[Docket No. FAA-2022-1647; Project Identifier AD-2022-01379-T; Amendment 39-22438; AD 2023-10-02]

Airworthiness Directives; Transport and Commuter Category Airplanes

Final rule.

Figure 1 to paragraph (g)(1)(i)— *Fundamental Effective Isotropic PSD at Outside Interface of Airplane Antenna*

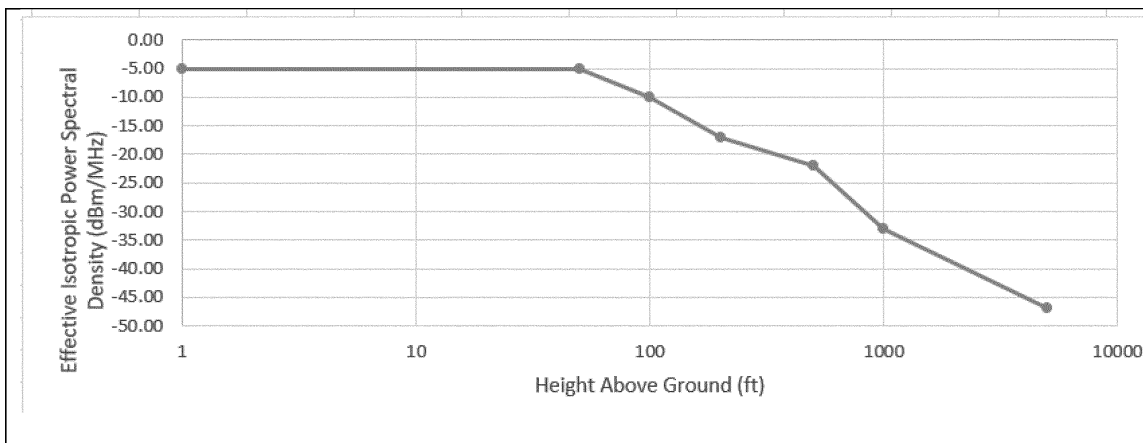
Comment summary: Textron Aviation requested the FAA clarify at what reference point the PSD requirements apply. The commenter stated it assumed that they apply at the radio altimeter receive antenna input, such that antenna characteristics, coax loss, and filter characteristics would be included in the determination.

FAA response: The FAA agrees and has changed the title of figure 1 to paragraph (g)(1)(i) of this AD to reflect that the PSD requirements apply at the antenna input to the radio altimeter, and that the figure applies to the outward facing side of the antenna.

Figure 2 to paragraph (g)(1)(ii)— *Spurious Effective Isotropic PSD at Outside Interface of Airplane Antenna*

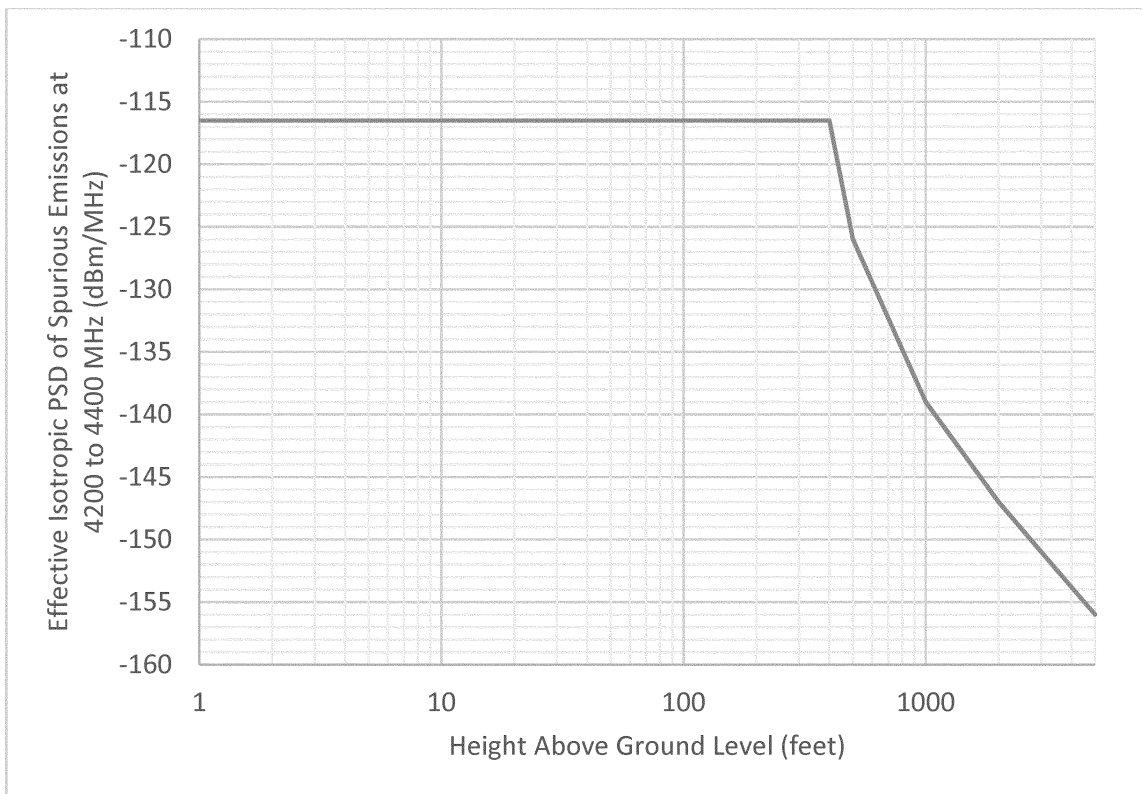
Comment summary: AIA requested that the FAA provide more information about the tolerances for determination of whether an airplane is radio altimeter tolerant. Several commenters requested that the FAA add a new figure indicating the spurious tolerance, similar to the figure with the PSD tolerance curve, and a specification of the altitude dependence for spurious tolerance.

FAA response: The FAA agrees and has replaced the proposed fixed emission level with a spurious PSD tolerance curve in figure 2 to paragraph (g)(1)(ii) of this AD. Subsequent figures have been redesignated accordingly.
